BW - 25

RE: Salado Brine BW-025

From: "Price, Wayne" <WPrice@state.nm.us>
To: "Eddie Seay (E-mail)" <seay04@leaco.net>
Sent: Monday, May 23, 2005 9:48 AM
Subject: FW: Salado Brine sales BW-025 minor modification

Salado Brine Sales BW-025

PROPOSED MONITOR WELL SCHEMATIC

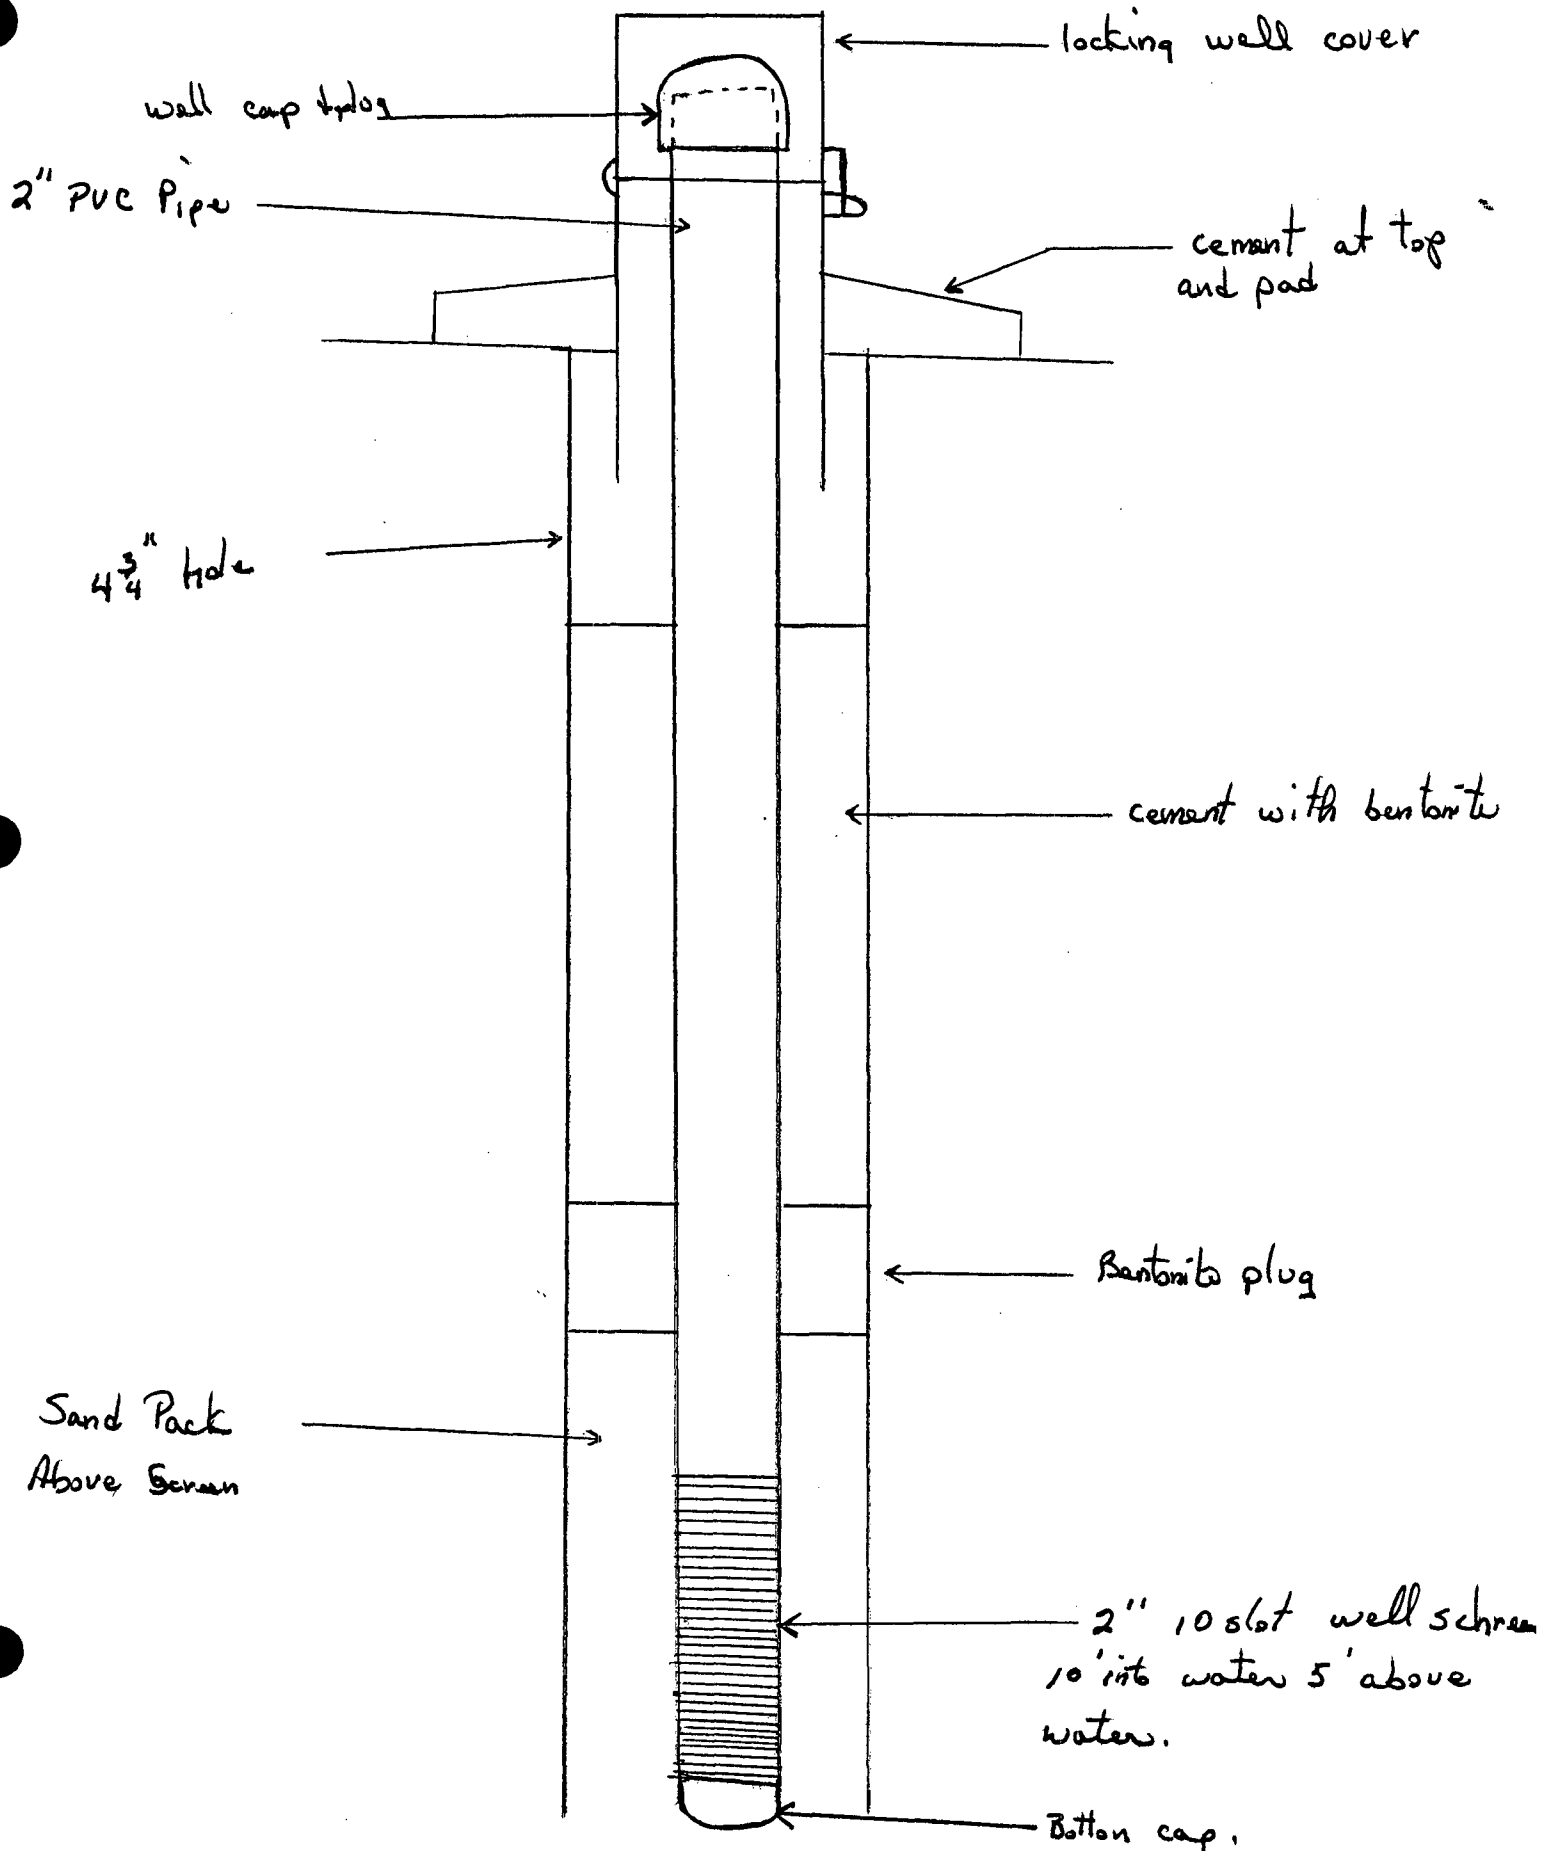
- 1) Salado has been in contact with a drilling company and is on the list to install a monitor well. I have enclosed a schematic of the proposed completion for your approval.

The MW is to be installed down gradient to the brine well and clean out pit. The ground water gradient in this area is SSW. (See plat of facility for proposed location.)

> 1. OCD recommends that the proposed monitor well be installed near the
 > southwest corner of the wash-out pit drying pad.

> 2. The new monitor well shall be developed, purged and sampled pursuant
 > to approved EPA methods. A geologic/lithologic log and well completion
 > diagram for the well shall be provided. The sample shall be initially
 > analyzed for BTEX (8021) and general chemistry. After initial sampling
 > this well shall be sampled twice a year including the other four wells
 > previously approved. These results shall be submitted in the annual
 > report.
